Public Notice is hereby given that SUMMIT COAL COMPANY, INC. has submitted to the UTAH DIVISION OF OIL, GAS AND MINING a COAL EXPLORATION PLAN FOR MORE THAN 250 TONS.. This plan was submitted to the division on February 29, 1984 with additional information submitted on April 20, 1984. Public comments regarding this plan can be submitted in writing for 30 days from the date below to:

September 7, 1984

Attached is the additional information requested by the Division. The format is that of a question-answer. Each concern is stated in its entirety and the reply is addressed to each. Some of the data and maps is also contained in an appendix.

SUMMIT COAL COMPANY REPLY TO
TECHNICAL DEFICIENCY REVIEW

Soil Depths

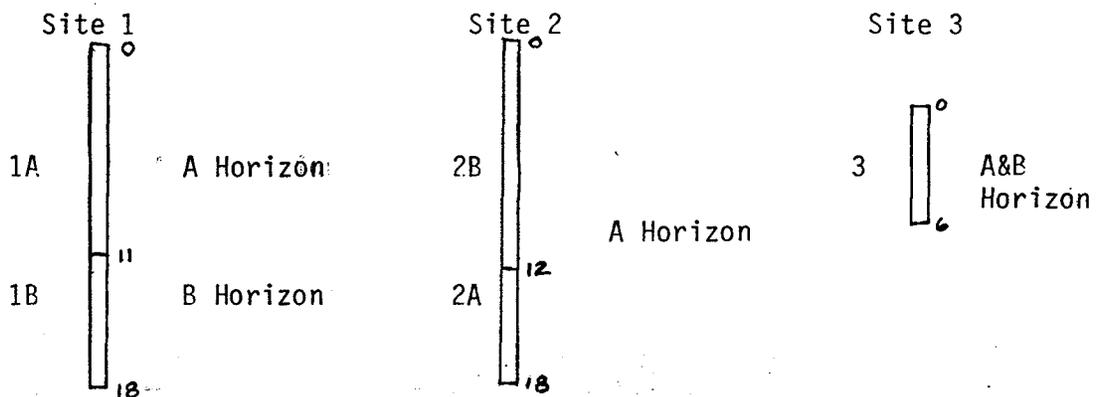
Out of 6 areas
why only 3 sites
sampled?

Each series was sampled.

SUBJECT TYPICAL PORTAL SEALING
Scale - 1" = 20'

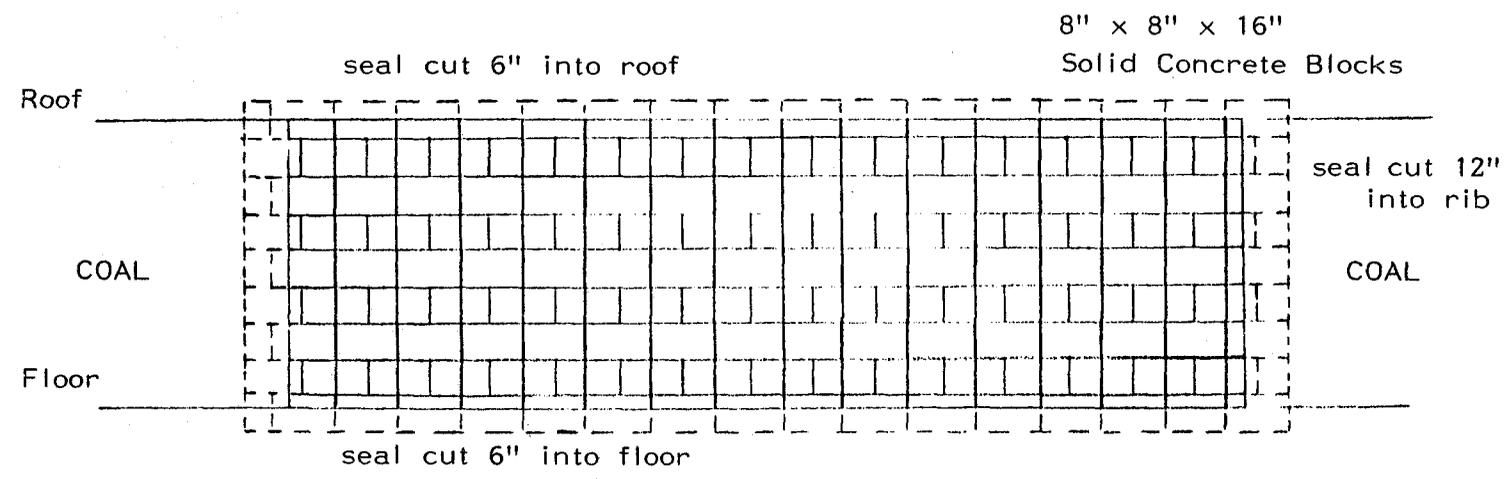
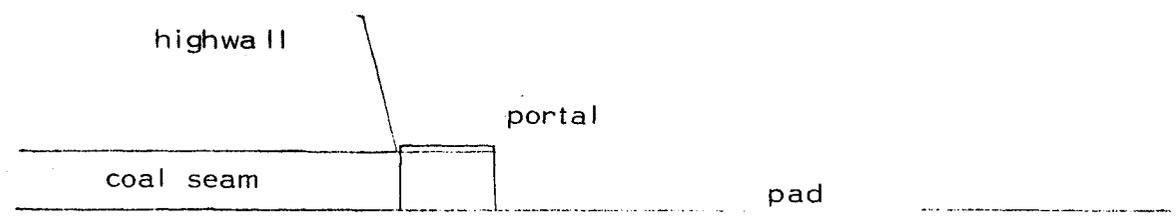
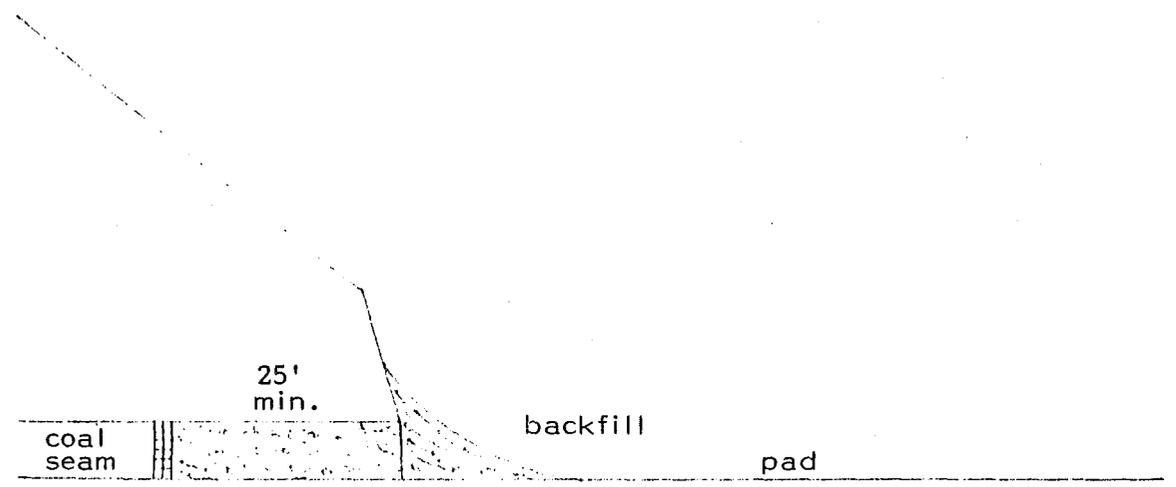
Permanent closure of mine openings has not been addressed in the CEP deficiency response. The applicant must respond to sections UMC 817.13 - .15 as required. Temporary and permanent closures shall be equal or superior to those required under 30 CFR 75.1711.

Sealing of Mine Openings

Based on hydraulic and geologic data from this area, mine drainage will not be a problem, and hydrologic seals are not required. Details of the seals are shown on the enclosed figures.
